Access Compliance Report

Public Rights-of-Way

(Curb Ramps)

Intersection ID: 21612	Main Street: ORDWAY_CT	Cross Street: SARDIS_OAKS_RD	Location: NE
ADA ID: DFF9DCE99E12	Ramp Type: PerpDiag	Initial Pass/Fail: Fail	Overall Compliance: No
		Severity Score: 13.75

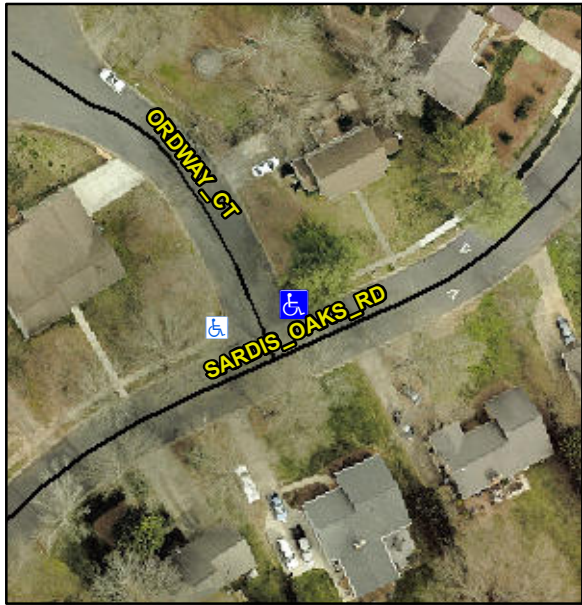
Codes/Mitigation Info/Possible Solution		Field Measurements/Component Compliance							
	Possible Solutions:	Compliance		Description	Data	Compliance		Description	Data
	Remove & Replace Curb Ramp With Two New Directional Ramps or Equivalent.	N/A	Ramp Length (in)	49.0	No	Ramp Slope (%)	9.5		
		Yes	Ramp Width (in)	48.0	No	Ramp XSlope (%)	3.6		
		N/A	Flare Type LT	N/A	N/A	Flare Type RT	N/A		
		N/A	Flare Slope LT (%)	N/A	N/A	Flare Slope RT (%)	N/A		
		N/A	Flare Traversable LT?	N/A	N/A	Flare Traversable RT?	N/A		
		N/A	Landing Length (in)	N/A	N/A	DWS Provided?	N/A		
		N/A	Landing Width (in)	N/A	N/A	DWS Contrast?	N/A		
		N/A	Landing Slope (%)	N/A	N/A	DWS Length (in)	N/A		
		N/A	Landing X Slope (%)	N/A	N/A	DWS Full Width?	N/A		
Surveyor Notes: N/A	N/A	Landing Curb? (Y/N)	N/A	N/A	DWS Offset (in)	N/A			
	PROW/ADA: R304.2.2, R304.5.3	N/A	Shared Landing?	N/A					
		N/A	Gutter Ponding?	N/A	N/A	Gutter Slope (%)	N/A

N/A	Gutter Lip Ht (in)	N/A	N/A	Gutter X Slope (%)	N/A		
		N/A	Painted X Walk1?	No	N/A	Painted X Walk2?	No		
			X Walk 1 Direction	To W		X Walk 2 Direction	To S		
		N/A	X Walk 1 Width (in)	N/A	N/A	X Walk 2 Width (in)	N/A		
			X Walk 1 Slope (%)	3.6		X Walk 2 Slope (%)	5.1		
			X Walk 1 X Slope (%)	3.7		X Walk 2 X Slope (%)	1.4		
		N/A	Ramp inside XWalk1?	N/A	N/A	Ramp inside XWalk2?	N/A		
Street 1 Name ORDWAY CT Stop Condition-Street 2 StopSign Street 2 Name SARDIS OAKS RD Stop Condition-Street 1 None		Road Slope (%)	2.6	N/A	Clear Space?	N/A			
		Road X Slope (%)	4.6	N/A	Clear Space to XWalk (in)	N/A			
	N/A	Any Obstructions?	N/A	N/A	Storm Grate/Utility Hazard?	N/A			
		Obstruction Type			Storm Grate/Utility Type				
				N/A		N/A			
				Yes	Surface Condition? (G/P)	Good			
Total Cost:		\$	3200.00
